Final Drainage Report – Early Grading Permit

Waterview East Commercial El Paso County, Colorado

PCD Filing No.: SP-22-009

Prepared: August 10, 2023

WATERVIEW EAST COMMERCIAL
CONSTRUCTION DOCUMENTS
PROPOSED DRAINAGE MAP - EARLY GRADING

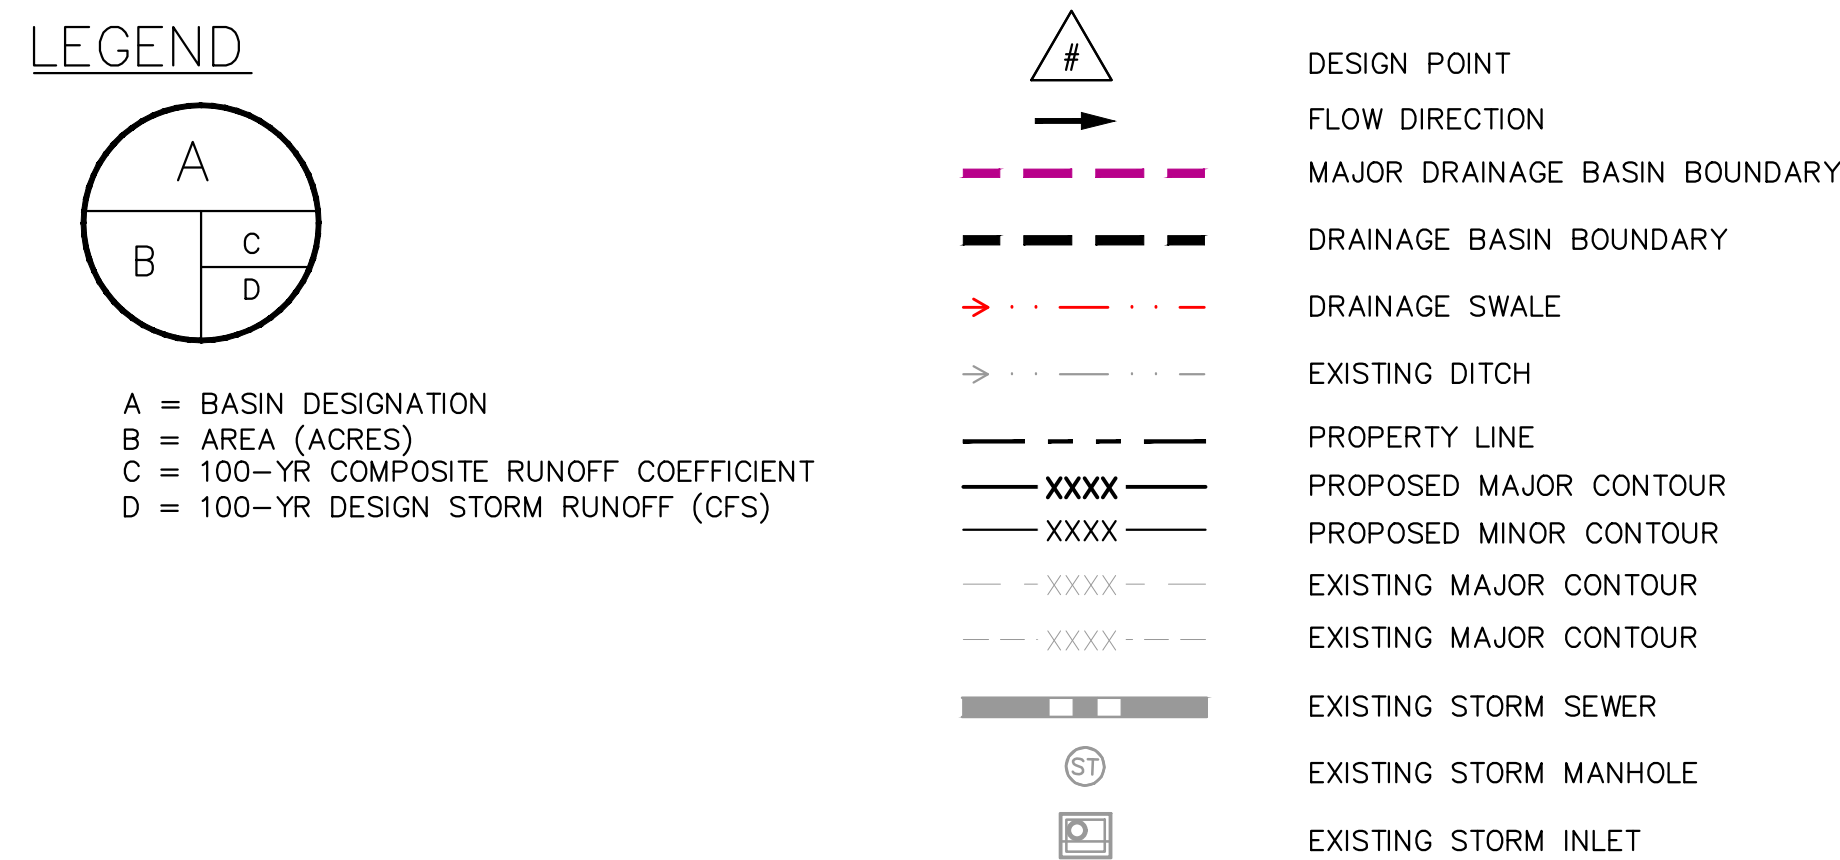
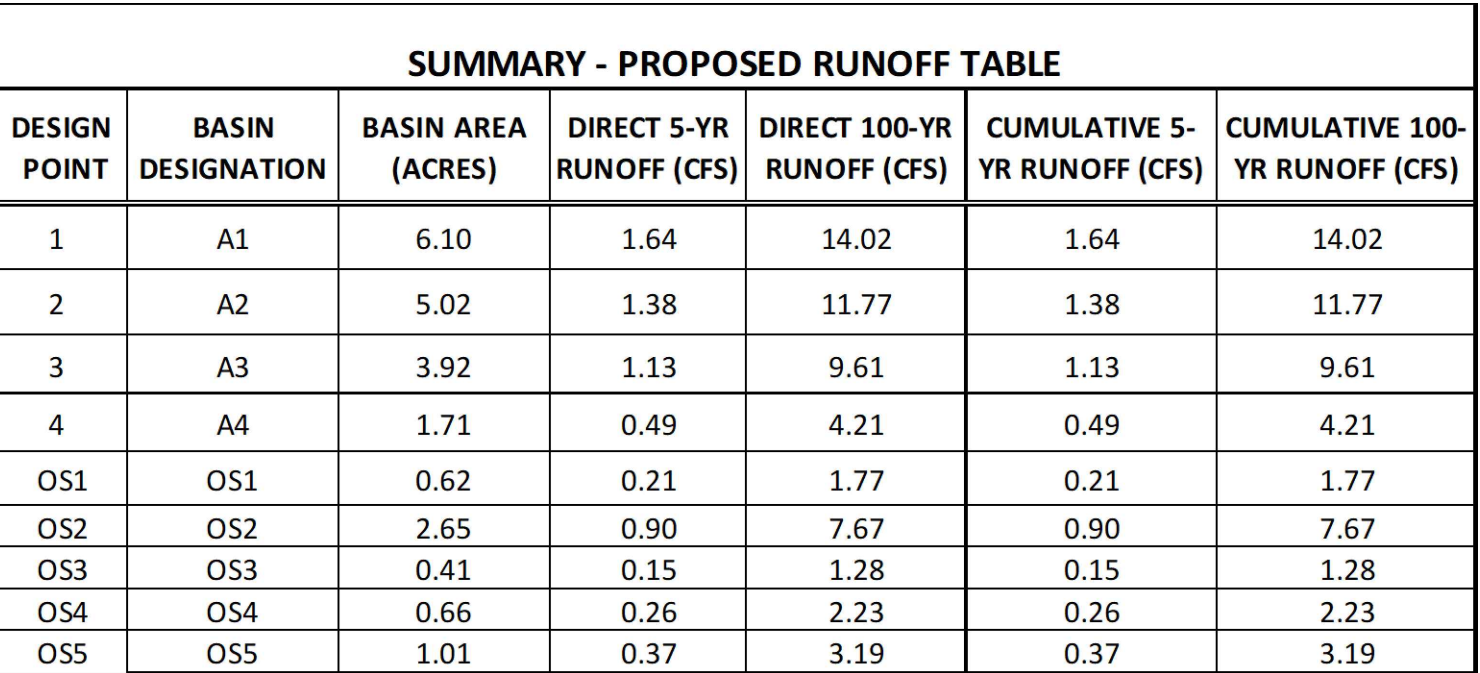
It appears that secondary ditch has been created.
Please revise grading to remove.
